**NUMBER:** 16-001-13

**GROUP:** Prop Shaft / U-joint

Driveline Vibration

2012                      DP                                      Ram 4500/5500 Cab Chassis

**Fig. 1 Drive Shaft Center Support Bearing Bracket**

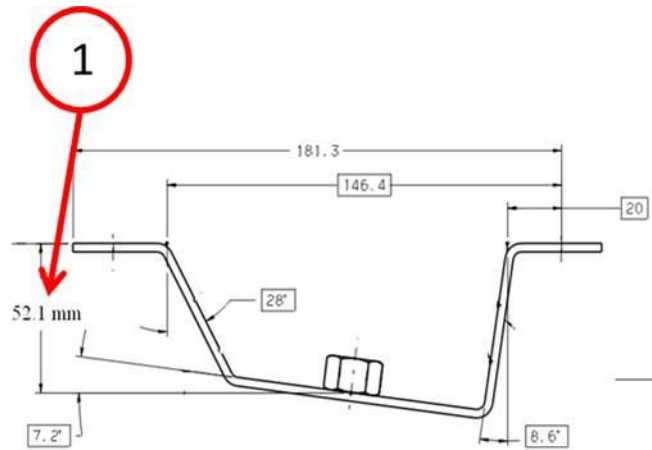
A small number of vehicles were built with an incorrect drive shaft center support bearing bracket. The bracket on these vehicles may have an incorrect height which could allow the drive shaft to operate at an angle that could cause the driveline to vibrate while the vehicle is in motion.

2. Measure the height of the drive shaft center support bearing bracket from the attaching fastener to the frame rail (Fig. 1). The distance should be 52.1 mm (2 inches). Incorrect drive shaft center support bearing brackets will be 82 mm (3.25 inches).

3. Was the height of the drive shaft center support bearing bracket 52.1 mm (2 inches) from the attaching fastener location to the frame rail?
  - a. YES>>>This vehicle has the correct drive shaft center support bearing bracket and does not apply to this service bulletin.

8. Install new drive shaft center support bearing bracket (p/n 52123065AB) securing it with the attaching fasteners. Tighten the bolts to 54 N·m (40 ft. lbs.).
